**Interpretation:** Insulation is not required to fill floor cavity to achieve Grade I

**Designation:** IR 301-2019-023

**Approved:** April 18, 2021 by RESNET SDC 300

Standard	<u>ANSI/RESNET/ICC 301-2019</u>
Page Number(s):	<u>A-2</u>
Sections(s):	<u>A-1.3.2</u>
Table(s):	<u>n/a</u>
Relating to:	<u>Insulation installation criteria</u>

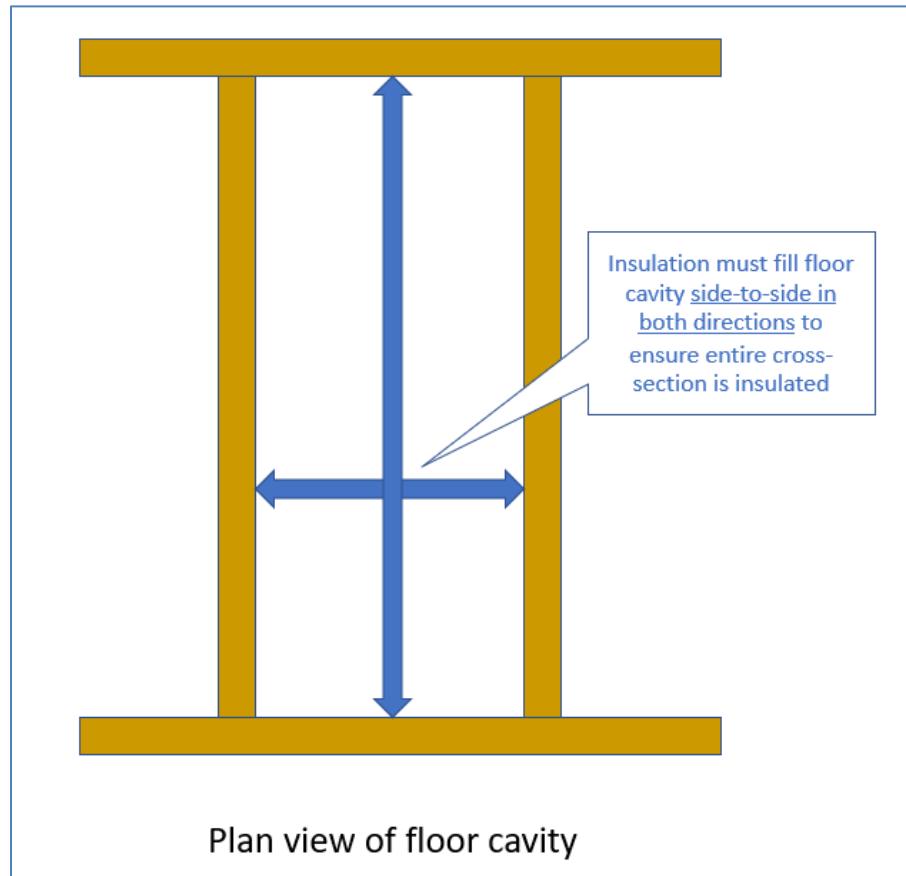
One might interpret that the requirement to fill a cavity side to side and top to bottom is only applicable to wall cavities, where this requirement would ensure that the entire cross-section of the cavity contains insulation, as illustrated below:

Note that the section does not require the wall cavity to be filled front-to-back (i.e., to fill the entire volume of the wall cavity with insulation) to achieve Grade I or II.

To achieve the same intent in a floor cavity (i.e., ensure that the entire cross-section of the cavity contains insulation) the insulation would need to extend side-to-side in both directions:

Again, note that the floor cavity would not need to be filled top-to-bottom to achieve this intent (i.e., the entire volume of floor cavity would not need to be filled to ensure that its entire cross-section is insulated).

This interpretation is correct. The underlined format was added to note that the interpretation request was specific to one specific floor insulation technique, as described in A-1.2. However, for additional clarity, this interpretation also applies to the other floor insulation techniques that are described in the Exception to A-1.2.

Where following that Exception, this same interpretation applies: the floor framing cavity insulation must extend side-to-side in both horizontal directions to meet A-1.3.2, but is not required to be insulated from the “top to bottom” of the floor cavity in order to achieve Grade I or II.
